Technical Service Bulletin

68 Noises from dash panel around MMI display

68 19 23 2056298/1 September 27, 2019.

Model(s)	Year	VIN Range	Vehicle-Specific Equipment
A6, A7	2019	All	Not Applicable

Figure 1. Apply felt strips to the circled areas.

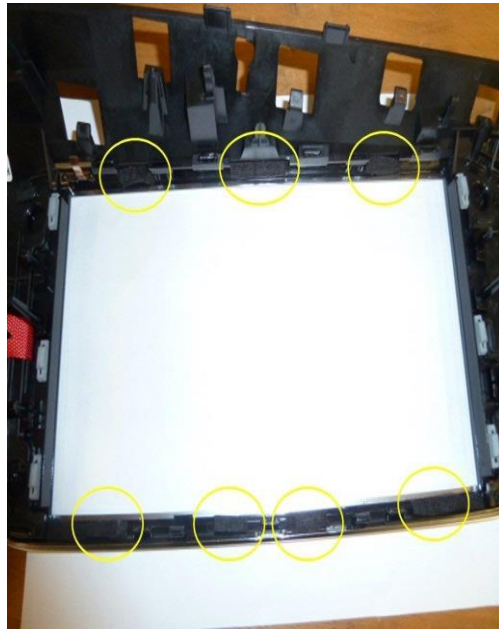
- Felt strips 533 867 910A.
1. Remove the trim strip of the dash panel and stick the felt adhesive tape on the areas marked with yellow circles.

2. The felt strips shown in Figure 1 and 2 must be stuck on and folded back behind the clip.
